WOKINGHAM BOROUGH COUNCIL TOWN AND COUNTRY PLANNING ACT 1990 (AS AMENDED) SECTION 78 APPEAL

Planning Inspectorate APP/X0360/W/25/6005646

LAND WEST OF EDNEY'S HILL, BARKHAM ROAD, BARKHAM, RG41 4TG

REBUTTAL EVIDENCE – TREES

FIGURE 1 - GIRTH CHART FOR VARIOUS SPECIES OF TREES FROM 'LONSDALE'

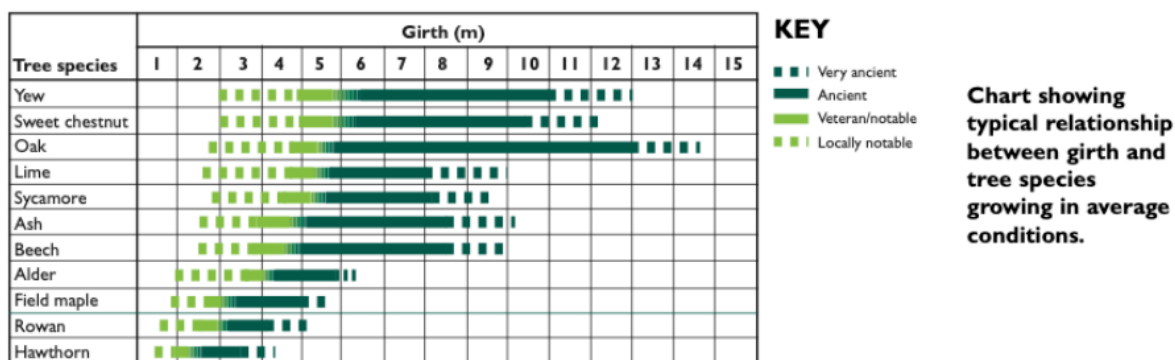
5.6 Some consultants interpret Figure 1.3 incorrectly. Taking the baseline or starting point of the columns on girth at 1m so that for an oak to be an ancient tree the girth must be around 5.7m (where the solid lime green line in the 'Oak' row of the table turns to a solid dark green). The correct interpretation is to read Figure 1.3 with the columns start with the line running down the extreme left of the 'Girth' columns, read as '0'. A clearer visualisation of this is presented below.

5.7 This misreading of the table is not an uncommon one.

FIGURE 3 - FIGURE 1.3 MODIFIED AND CLARIFIED TO ACCURATELY REFLECT DR LONSDALE'S EMAIL OF 8TH MARCH 2020

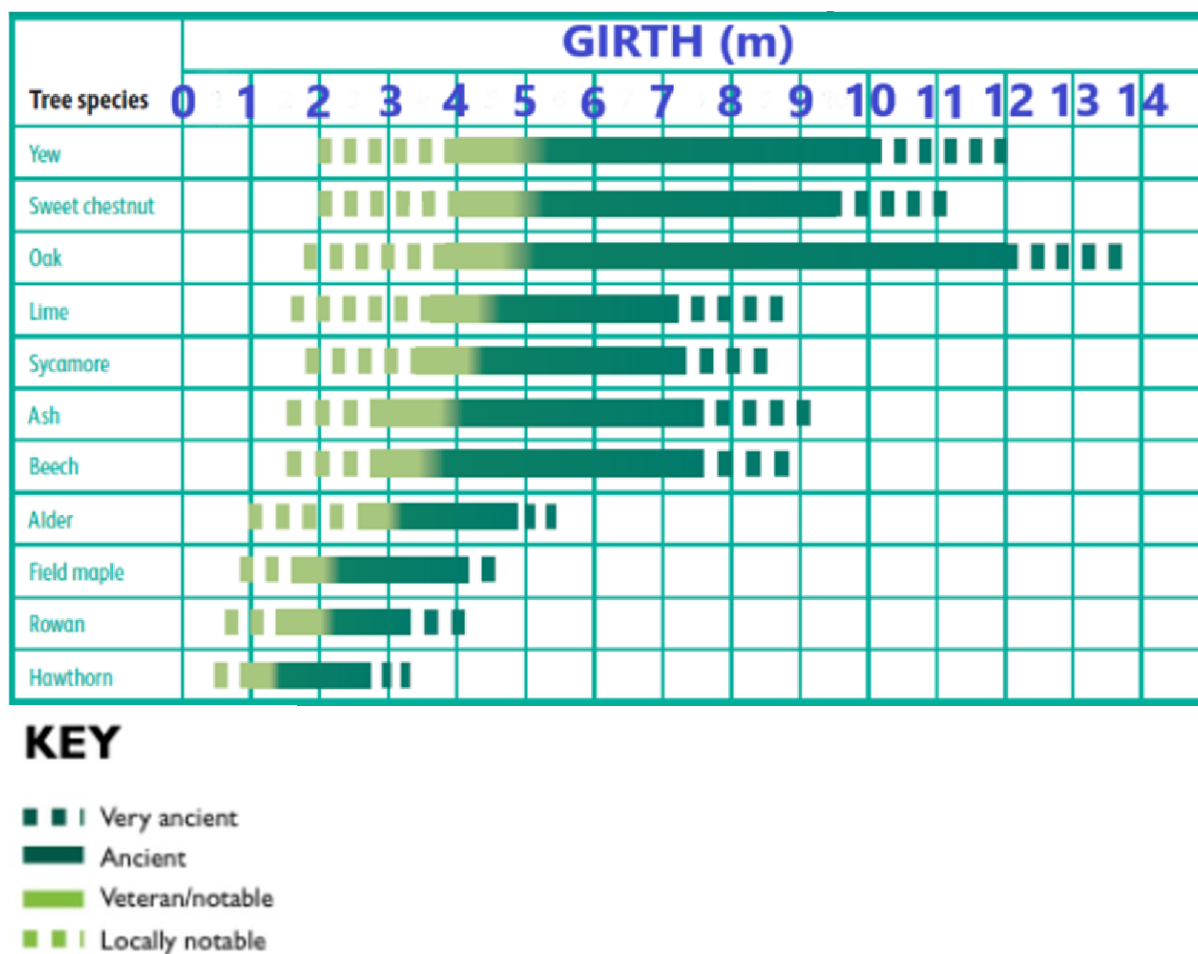
5.12 It is important to note that Dr Lonsdale said: '*an oak could qualify as a veteran with a girth of 3.75 m if it has other qualifying characteristics.*' So then, to edit

5.15 Examining the amended unambiguous version of Figure 1.3 we can see that the new Natural England BNG guidance is more in line with this amended version of Figure 1.3 than with the unamended Figure 1.3. Oaks, for example, being seen as ancient tree when they reach 4m girth in the newest NE guidance, 4.7m in the amended Fig 1.3 (incidentally the measurement we used in the Wealden Ancient Tree Survey twenty years ago) as opposed to 5.7 in the unamended Figure 1.3 as it is often (wrongly) interpreted.

5.16 Similarly, smaller oaks (and other species) can be considered veteran in both the NE BNG guidance and the amended Figure 1.3, than in the unamended version.

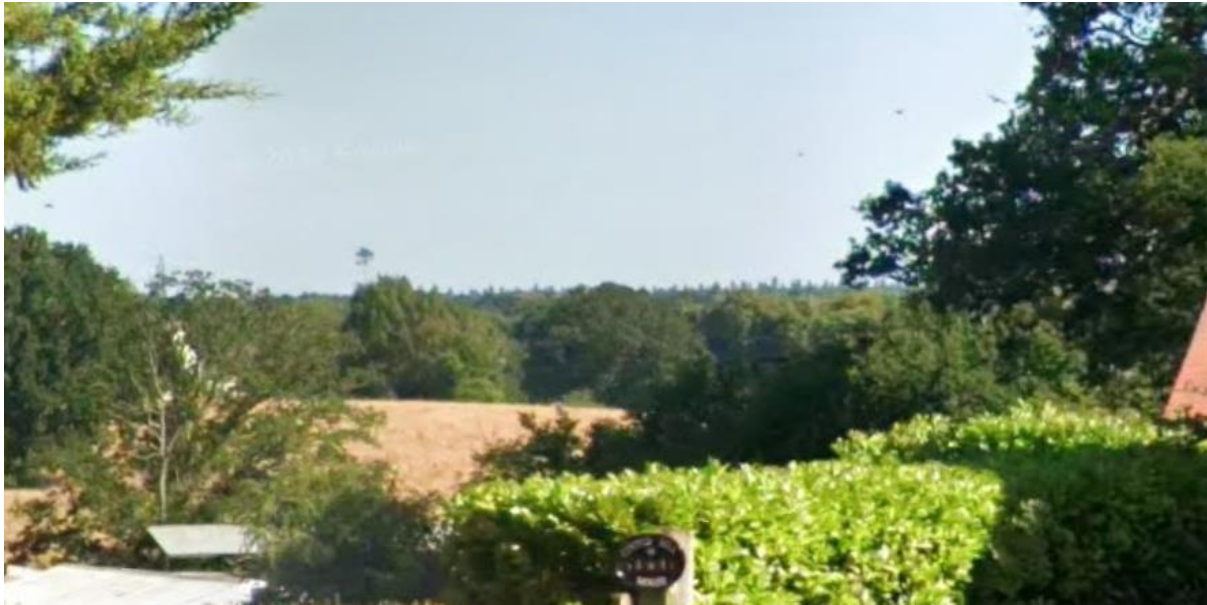
- 7.44 There are important views of the nationally significant Wellingtonia Avenue Sequoiadendron giganteum trees at Finchampstead 4.6 km to the south-east (see figures 3 and 4 below).
- 7.45 The saw-tooth silhouette of the iconic Wellingtonia Avenue tree canopies appears on the skyline when viewed across the site from the pavement outside the entrance to the property known as 'Nova' on Barkham Road.

- 7.46 This nationally significant Wellingtonia avenue was planted as a memorial to the late Duke of Wellington who lived in the area and who is commemorated in Wellington College at the eastern end of the avenue. Without straying too much into landscape evidence, this is an important view of this magnificent arboricultural feature, a feature of national significance.
